Re: Heil Pull Trailer Dolly Frame Recall
Manufacturer's Recall ID Code: EWR282

PART 573 Defect and Noncompliance Report

Heil's California Pull Trailer with air ride suspension

Fig. 1.1

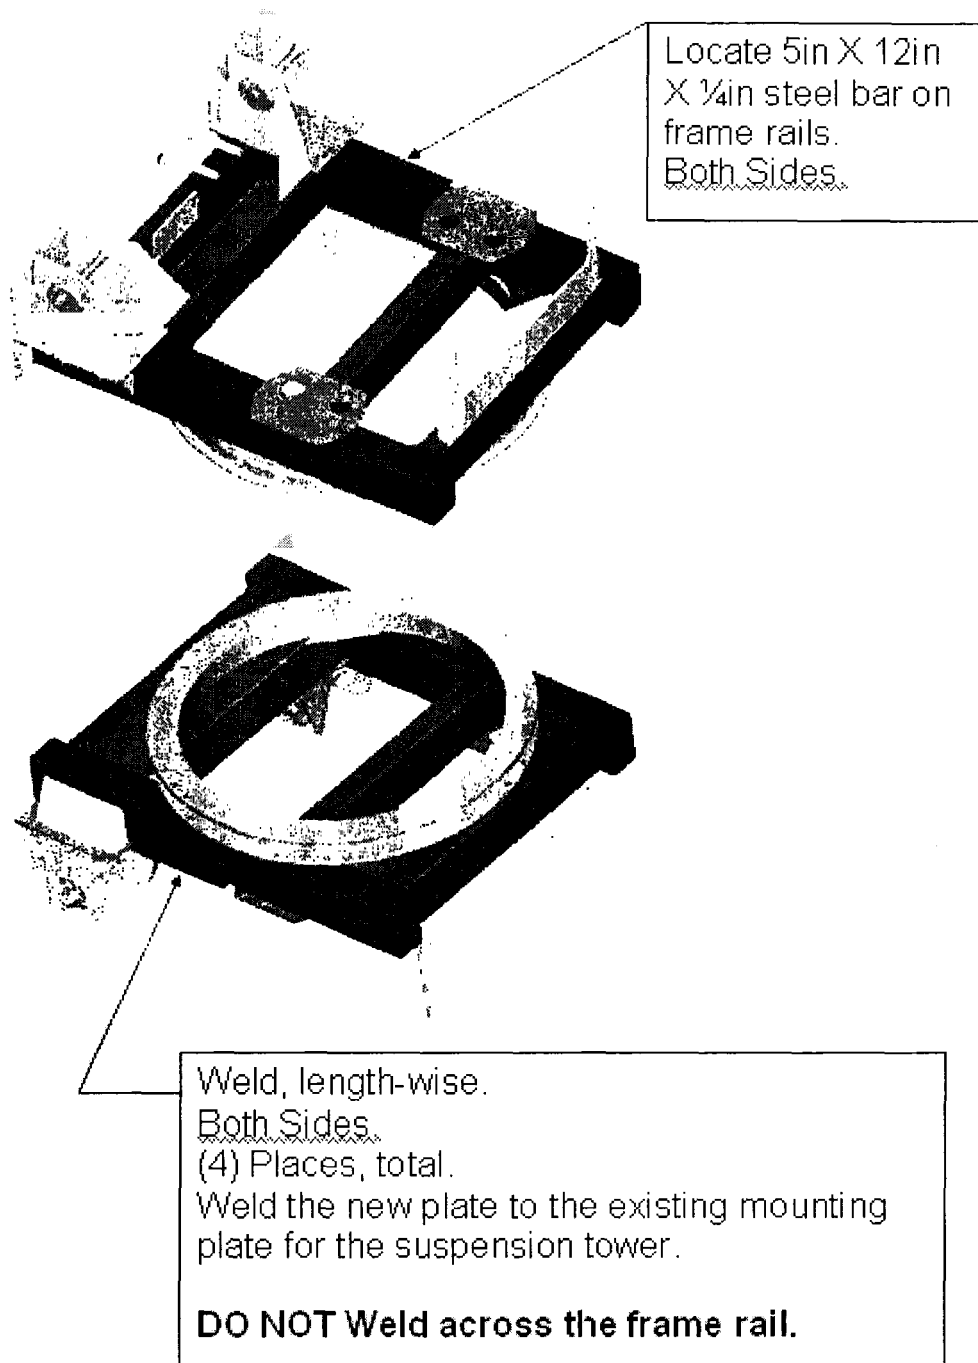
Modifications were made to the published weld procedures for the frame in question. Two distinct processes were used to communicate the revised procedure to manufacturing. (1) A weldment instruction (701-8078) was published to clarify welding procedures for the dolly frame. (See Figure 1.1.); and (2) A quality communication (2005-008) was published to clarify welding procedures for the dolly frame. (See Figure 1.2.) For the remedy condition, the tower plate welds and air bag plate welds are to stop ½" away from the edge of the frame rail. For the recall condition, the tower plate welds and air bag plate welds may continue to the edge of the frame rail.

For the remedy component/assembly, the tower plate welds and air bag plate welds are to stop 1/2" away from the edge of the frame rail.

For the recall component/assembly, the tower plate welds and air bag plate welds may continue to the edge of the frame rail.

Fig 1.2

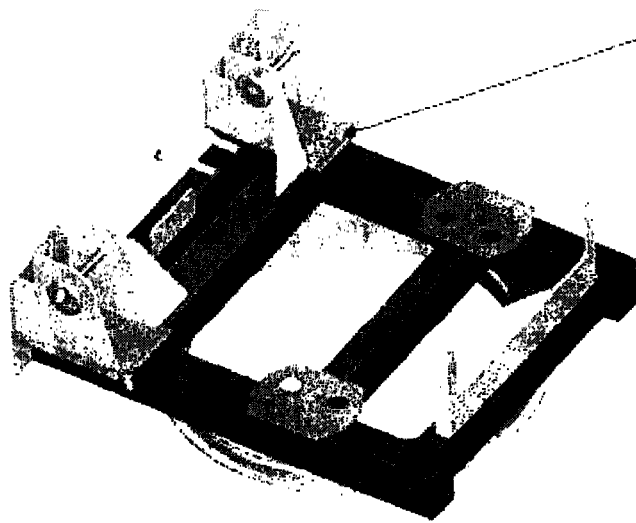
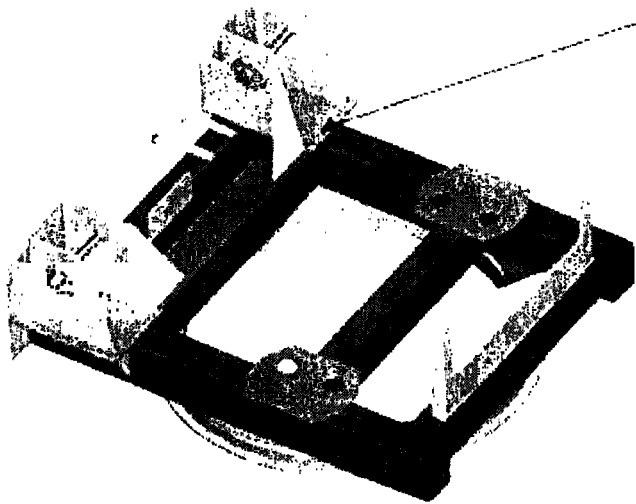
Mark plate at
 $\frac{3}{4}$ in from end.
Both Sides.

Cut and remove end
of plate at mark.
Both Sides.
Grind off existing
weld.
